Subject: Contract No. 200-2004-03805, Task Order 1: *Paducah Gaseous Diffusion Plant Site Profile Review*, SCA-TR-TASK1-0016

*Paducah Gaseous Diffusion Plant Site Profile Review*

**Contract No. 200-2004-03805  
Task Order No. 1  
SCA-TR-TASK1-0016**

**Figure 5.1-1. Schematic Drawing Showing Approximate Locations of PGDP Buildings**  
(Source: PACE/Utah 2000, Figure C-1)

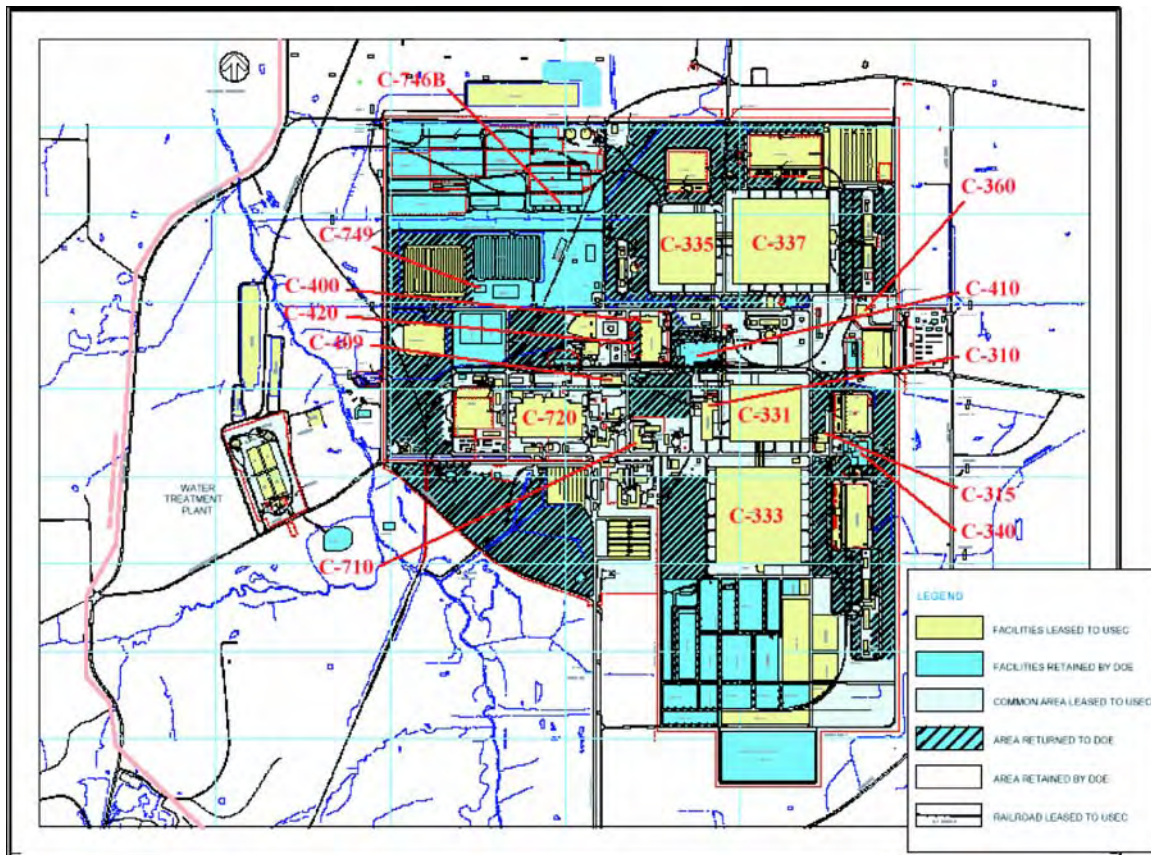
### 5.1.3 Issue 3: The Site Map in the TBD is Inadequate

The site description in Turpin (2006) provides very little information in terms of layout of process buildings, office buildings, storage and waste areas, holding ponds, etc. Unfortunately, the site map (Figure 2-2) is also uninformative. The PACE/Utah 2000 report site map (see Figure 5.1-1) shows the relative locations of the principal buildings and also identifies those that are currently leased to USEC. A good site map could provide the dose reconstructor with information such as the location of a worker relative to a nearby exposure source that might otherwise be overlooked.

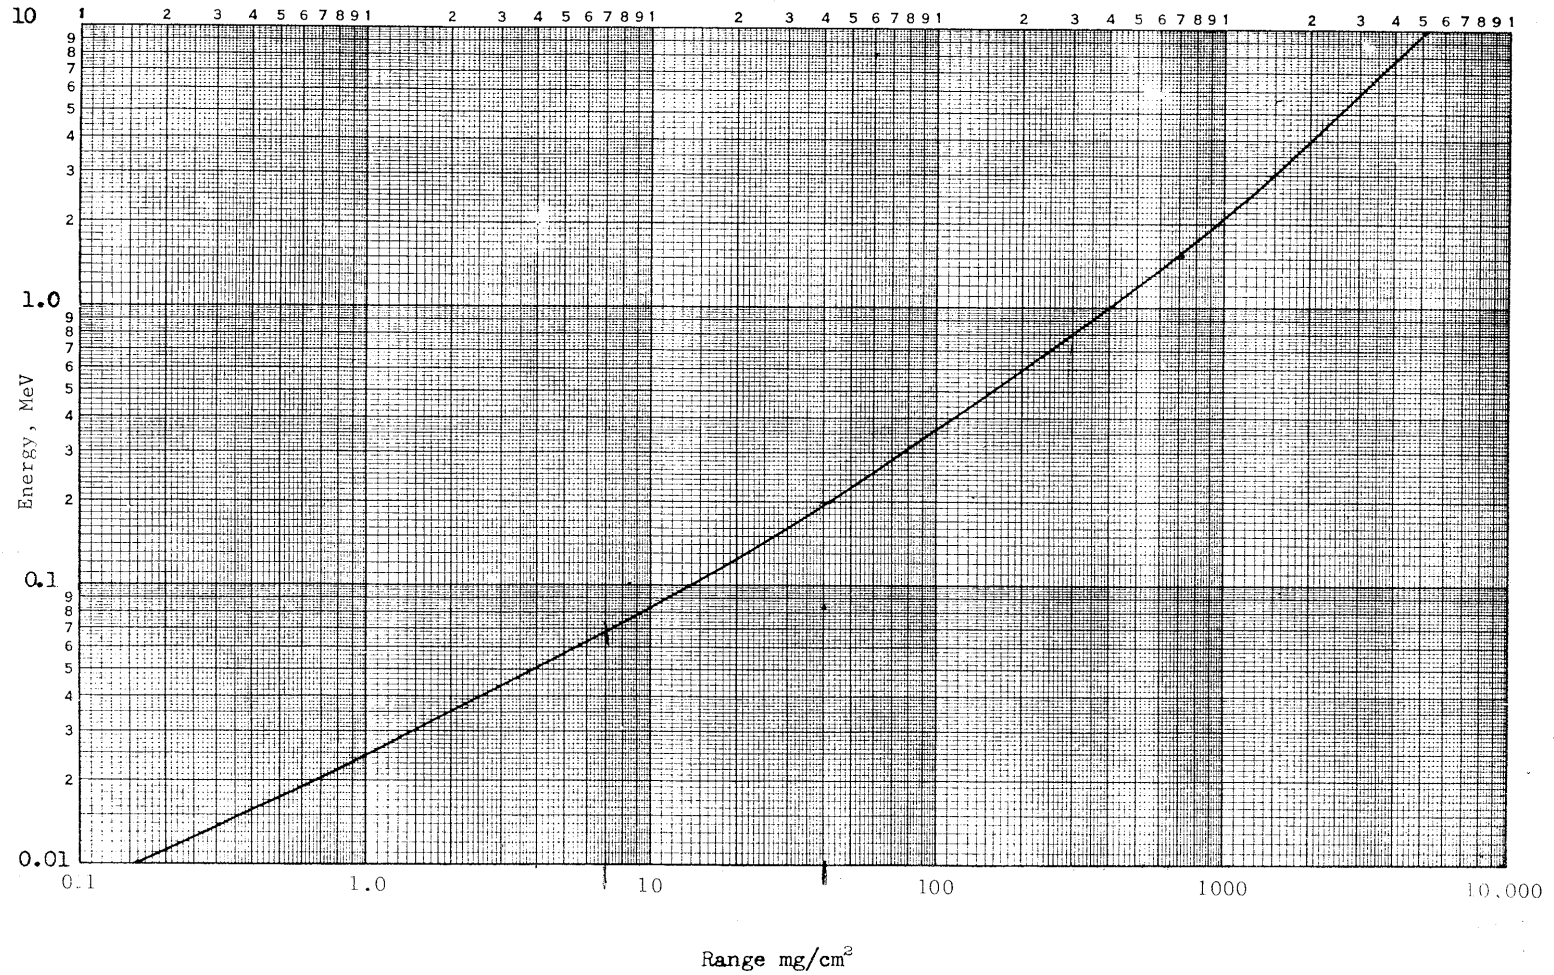
The high-energy beta of 2.29 MeV is emitted from Pa-234, which is the short-lived daughter of U-238. However, this simple “calibration” factor ignores the following lower-energy betas from short-lived daughters of U-238 and U-235, and from Tc-99 that would be completely absorbed by the 80 mg/cm<sup>2</sup> absorber:

While **all** of these betas would contribute to the 7 mg/cm<sup>2</sup> skin dose, **none** of these betas would have penetrated the 80 mg/cm<sup>2</sup> absorber and registered as a “dose” on the open window (see Exhibit #1, which defines the range of betas in an absorbing medium). Inspection of Exhibit #1 shows that a beta particle with energy >300 keV is required to penetrate an absorber of 80 mg/cm<sup>2</sup>. The magnitude of this deficiency is substantial and variable, since it is affected by the degree of U-235 enrichment and the contamination level of Tc-99.
